WR - 2618529

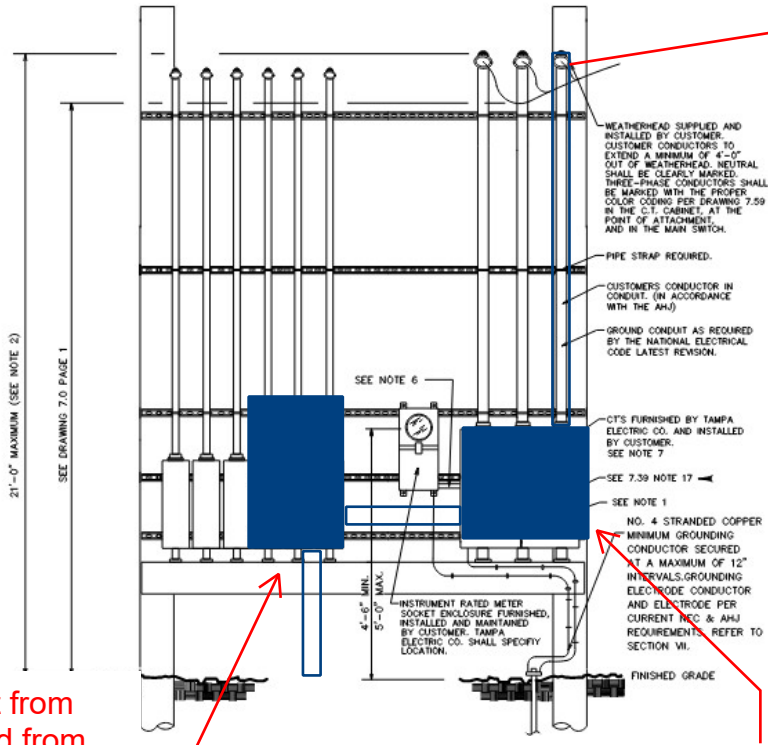
Double check there isn't a 2nd meter at this location...

Upgraded 120/208V 3P OH Service

New 600A Disconnect from trough or directly piped from the CT Cabinet. You can arrange this for your needs.

New Rack, CT Cabinet and Meter for 600A Service

WR - 2618530

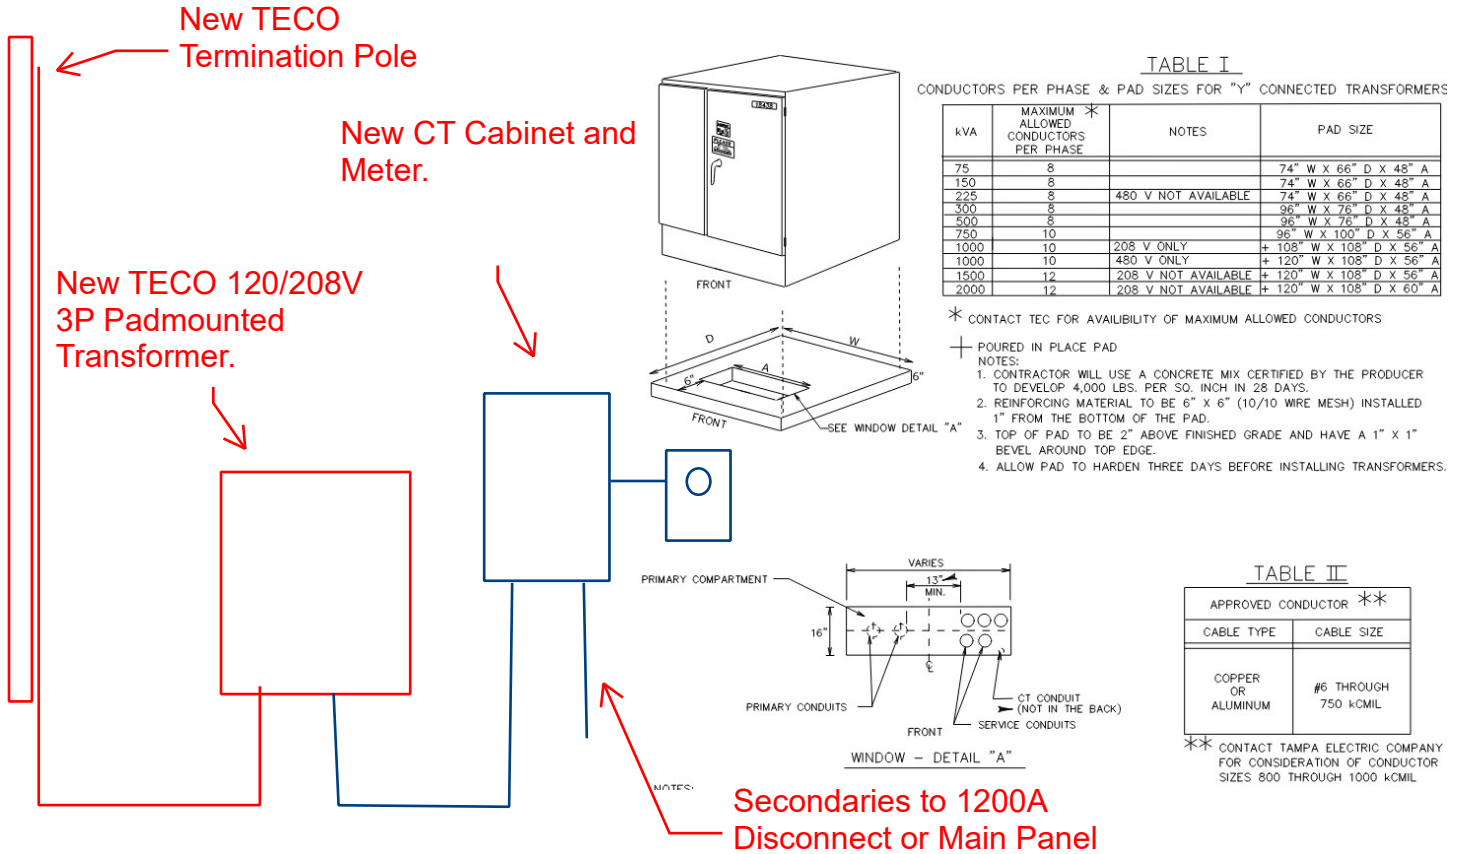
Double check there isn't a 2nd meter at this location...

Transformer also feeds TECO lighting from the Handhole.

Upgrade OH bank to 120/240V 3P Delta

Need to install (2) New 400A or Less Meter Cans and service risers at the building. TECO will install new secondary poles at the building to raise the OH secondary lines crossing the asphalt drive.
